# Change of Key Switch Connector (12P)

In the RoHS compliant models (A rank), the Key Switch connector (12P) has been changed as follows.

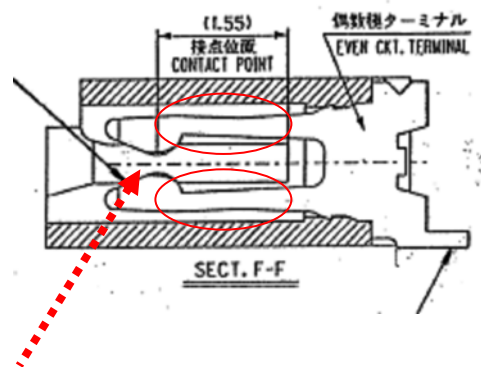
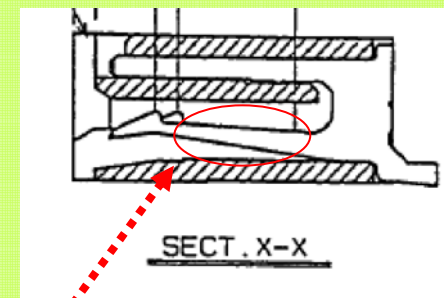
- Contact point: Top and bottom → **Bottom only**
- Connector type: MOLEX 52689-1293/1240 → **KYOCERA ELCO 086222012101848+**

Cross-section drawing of Connector for Non RoHS compliant models (A' rank)

Top and bottom contact point

Cross-section drawing of Connector of RoHS compliant models (A rank)

bottom contact point
